## INDEPENDENT URBAN DESIGN ADVICE

### Proposed Development at 9-13 Stewart Street Richmond

For City of Yarra

12 May 2022

### **Levels 4 to 7**

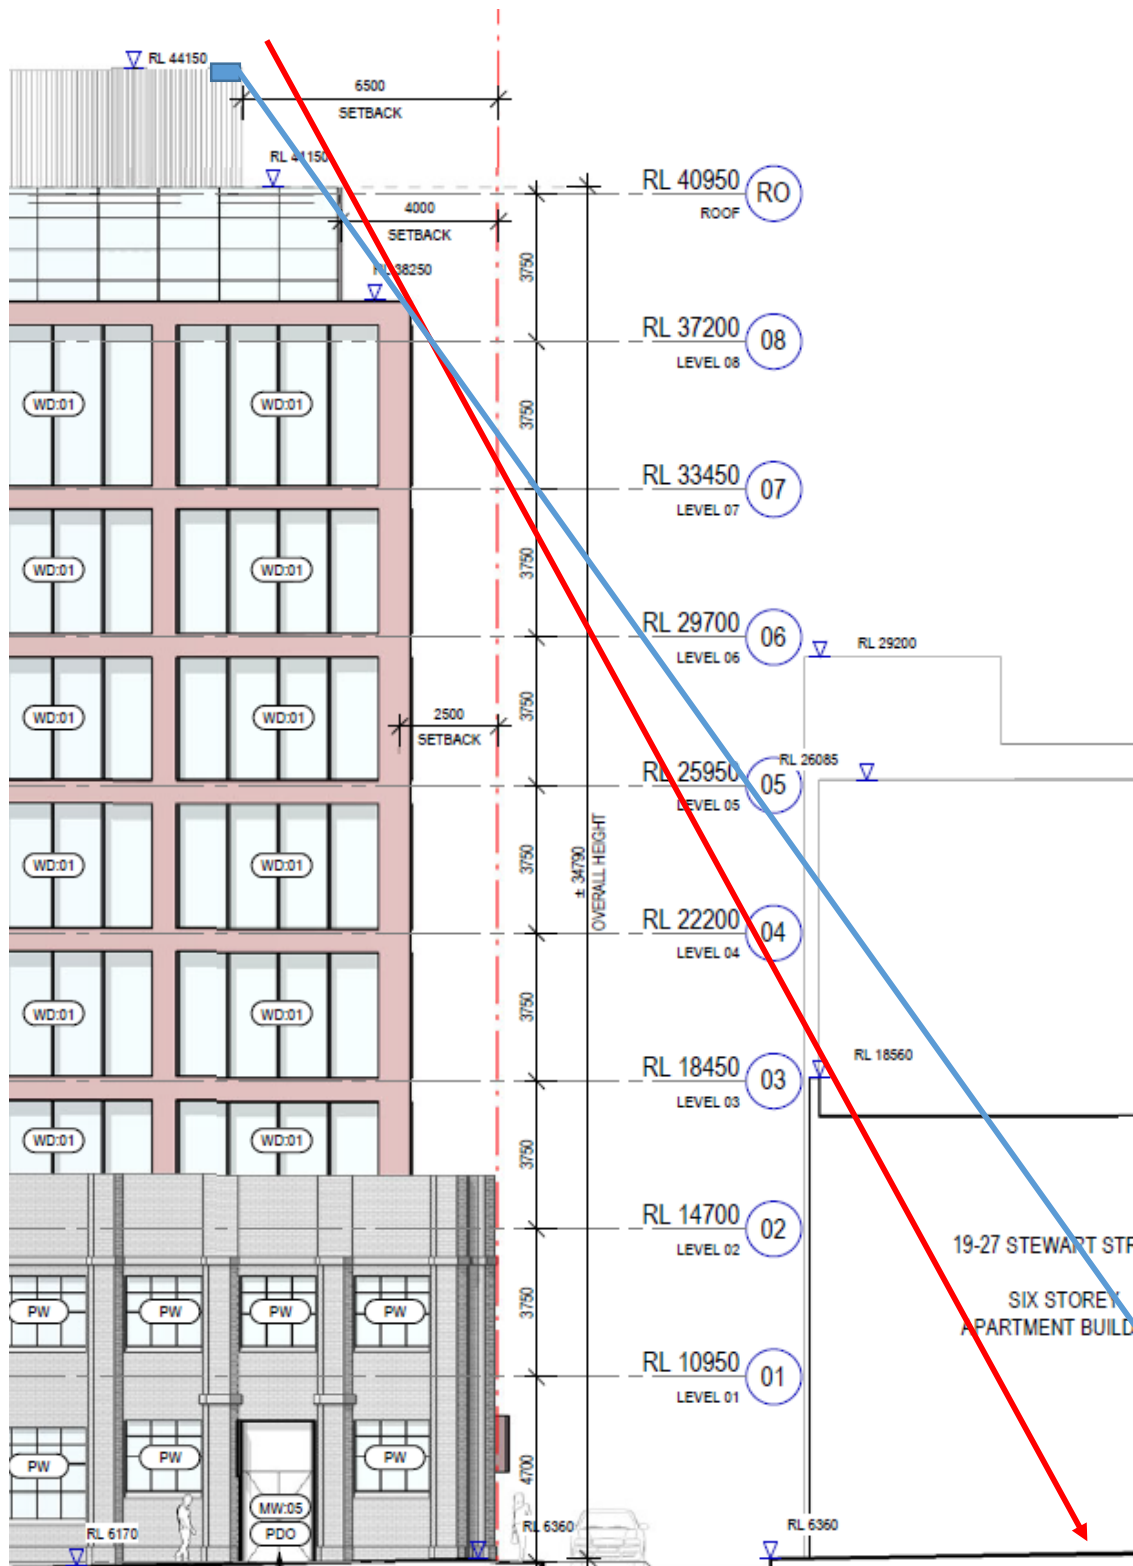
81. Continuation of 2.5m setback to the Stewart Street interface and 500mm reduction in length to the western boundary wall core.

82. Increased setback at Level 8 to 4.5m to Stewart Street (previously 2.5m) and 4m to Margaret Street (previously 2.5m save the on-boundary stair).
83. An external terrace is provided to the perimeter south and eastern facades and narrow 600mm terrace to the north with an increase in setback of 1m.

84. Removal of Level 9 and an increase plant area setback of 7m (previously 5m) to the Stewart St frontage and a reduction in setback of the plant by 1.5m to the northern residential interface from 8m to 6.5m. and an increase primary setback of 7m to the western frontage with a reduced-on boundary footprint.

85. The development's height has been reduced as follows:
  - a) To the upper roof parapet of the Level 8 the development is now envisaged as RI 41.15m
  - b) the expansive plant room façade now elevated and expressed to a consistent height of RI 44.15 interrupted only by the taller lift overrun.

- c) These heights compare to an upper-level parapet of RI 44.75 previously a reduction of 3.6m and a Plant room height of 47.95 now reduced by 3.8m.

- d) The rendering in the report seek to represent that Level 8 and the plant room would not be visible from the street. Given the setbacks and the distance back of the view this is not sustainable with visibility prominent in close proximity as view lines indicate.

- e) This analysis would suggest that the images within the revised submission simply cannot be correct and that the upper level 8 and plant will be highly visible from the station entry

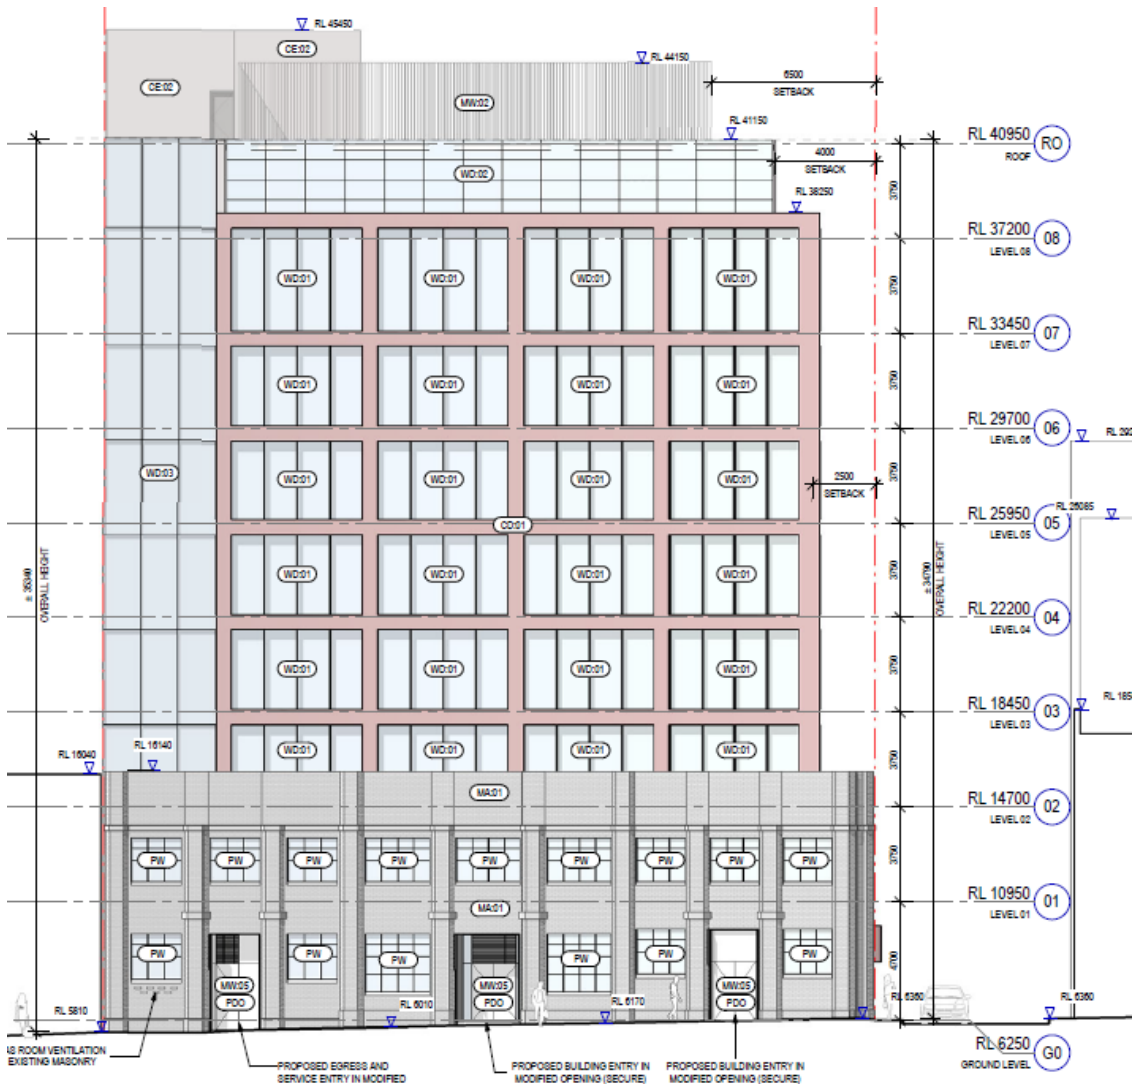
88. Additionally, the earlier development response indicated that significant screening and wind amelioration measures would be necessary, and the Tribunal noted these were likely to change the perceived response of the building to the heritage context.

89. None of the recommended screening initiatives recommended by the Wind mitigation report have been adopted in the revised elevations or plans before the Committee meaning the terraces proposed in the plans will not be fit for purpose. Additionally, the adoption of a single extruded form to the south and east facades is likely to amplify down draft outcomes and the concerns relating to the amenity of adjoining western and northern residents remains unresolved. Given the relative absence of easily accessible open space the provision of useful breakout spaces in the development is critical and the preservation of amenity of pedestrian areas surrounding the building and adjoining private residential open space similarly important.

90. The applicant should be asked to update plans with necessary measures so we can all determine what we are dealing with as a built form response and its responsiveness to the heritage and urban design policy settings in which it sits.

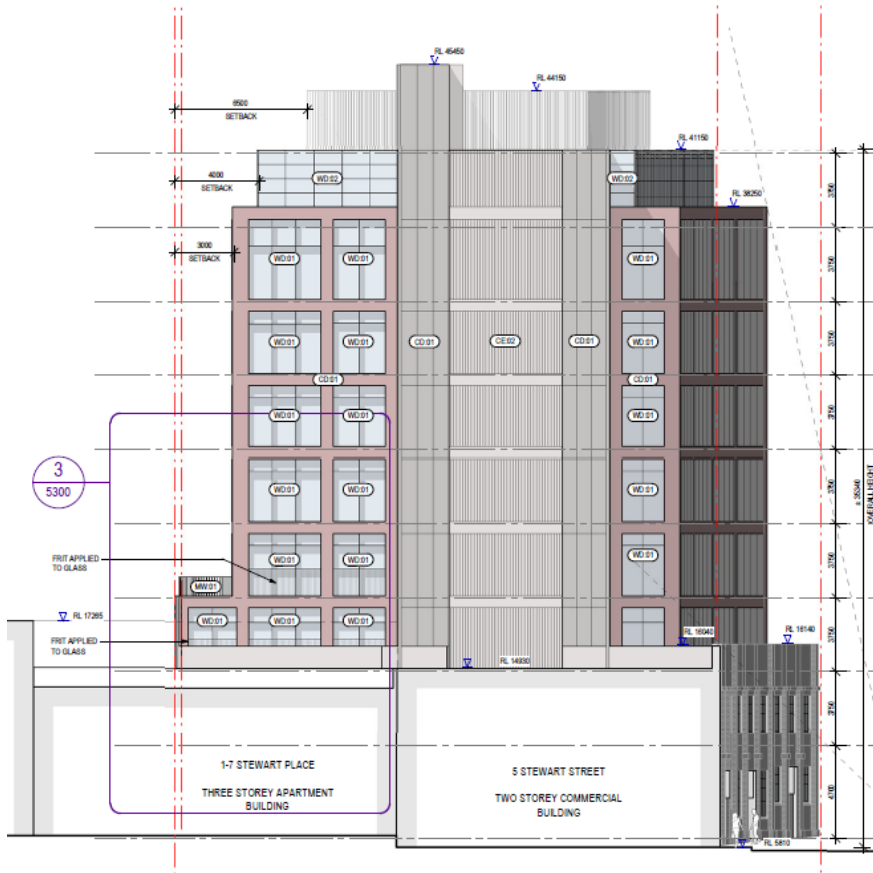
128. My view is that substantial lowering of the building is needed.

- a. Remove two floor levels, namely levels 6 and 7.
  - b. Either reintroduction a lightweight palette and design language that does not seek to inappropriately transpose warehouse and industrial architectural forms known and highly valued in the Richmond context into arrangements at odds with these traditions and in a form and setback arrangement that further amplify bulk or increase the setbacks to the primary and secondary street frontages in accordance with metrics similar to Swan Street i.e. 6m to Stewart St and 3m to Margaret St., to reduce the visual impact and confusing of heritage values arising from the limited setbacks and adoption of a masonry palette proposed in the revised plans.

129. This will reduce the height of the building by 7.5m to a foreground parapet height of RL 30.7 to the Stewart Street interface and overall height of nearly 31m to the large plant area screen level. This positions the building with its similar frontage length and larger site, though more constraining interface context at a height comparable through slightly larger overall than that at 31-33 Stewart Street.
